UNITED STATES PATENT AND TRADEMARK OFFICE

APPLICATION NO.	FILING DATE	FIRST NAMED INVENTOR	ATTORNEY DOCKET NO.	CONFIRMATION NO.
09/675,057	09/29/2000	Masaharu Tsuboi	0505-0692P	9453

Office Action Summary

DETAILED ACTION

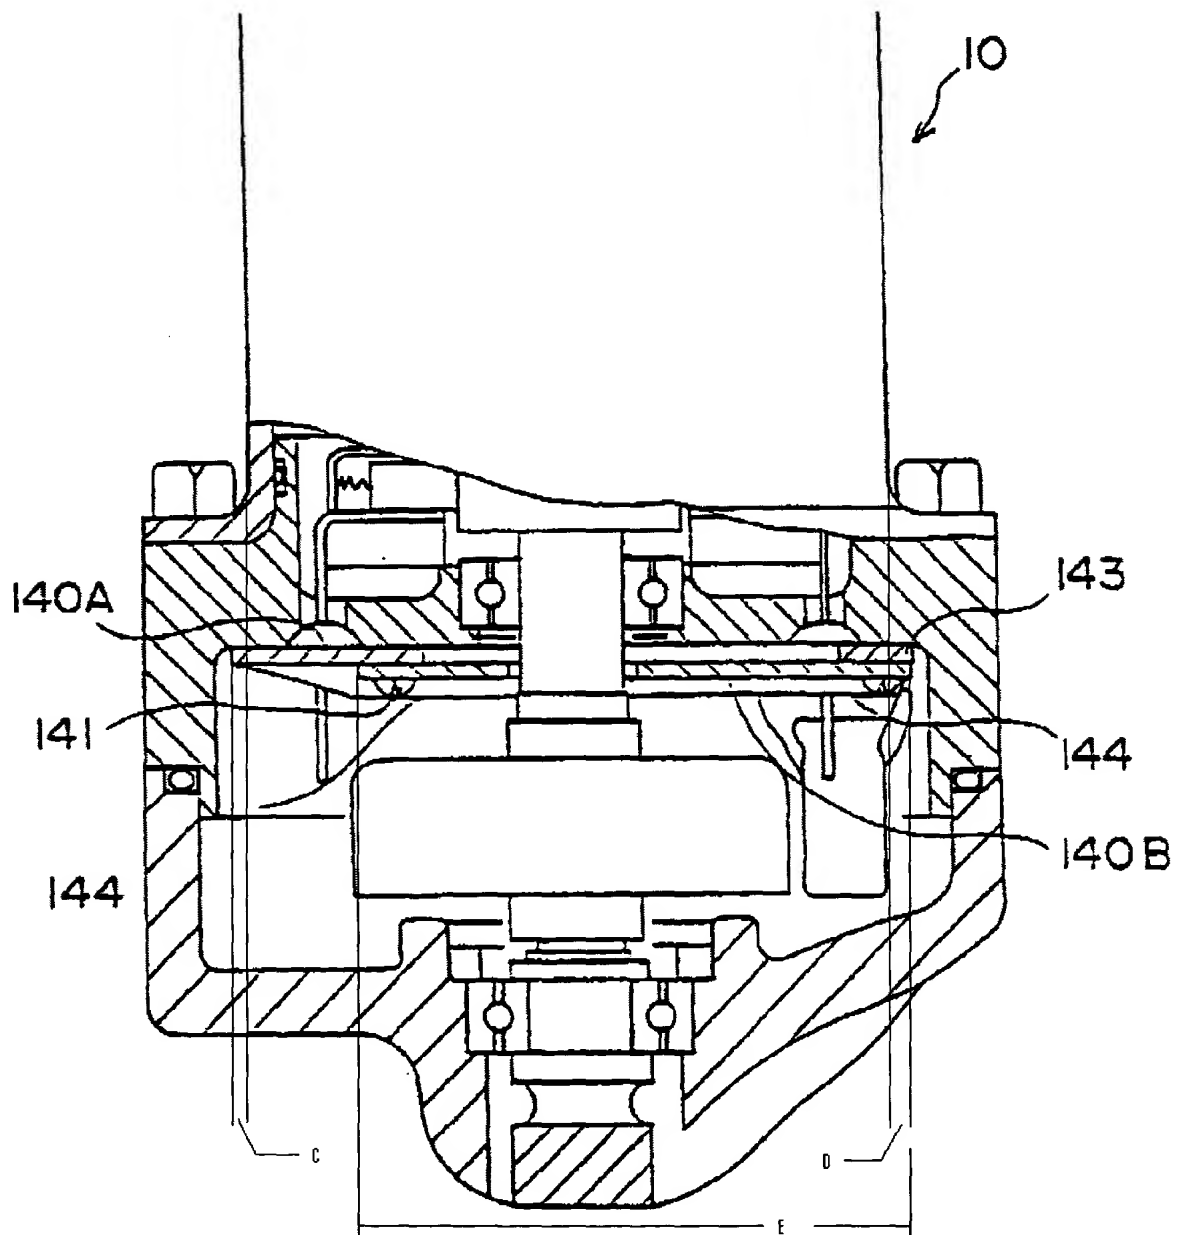
Referring to claim 1, Wakao et al. disclose a motor-assisted drive unit for a vehicle (*according to U. S. Pat. 6,268,669 which is a translation of the PCT document*), comprising:

a motor (10 in figure 13) having a shaft for providing power to a drive wheel of the vehicle; and

a first control board (140B) on which control devices (42) of the motor (10) are mounted, the first control board (140B) being arranged substantially perpendicularly to the shaft of the motor (10),

at least part of the first control board (140B) extending to a position overlapped with the motor (10), the first control board (140B) having a first region overlapped with the motor (10), and a second region (*C in the attached figure*) not overlapped with the motor (10).

Referring to claim 2, Wakao et al. disclose a second control board (140A) having a first region overlapped with said motor (10), a second region (*C in the attached figure*)

the second control board (140B) overlapping (*E in the attached figure*) with at least a part of the first control board (140A);

- a first region (overlapped with the motor (10), and
- a second region (*C in the attached figure*) not overlapped with the motor (10).

In response to Applicant's remark that Wakao fails to disclose a region not overlapped with the motor, it must be noted that the feature is shown not only in figure 18 but also in figure 13, a portion of which is attached to this action.
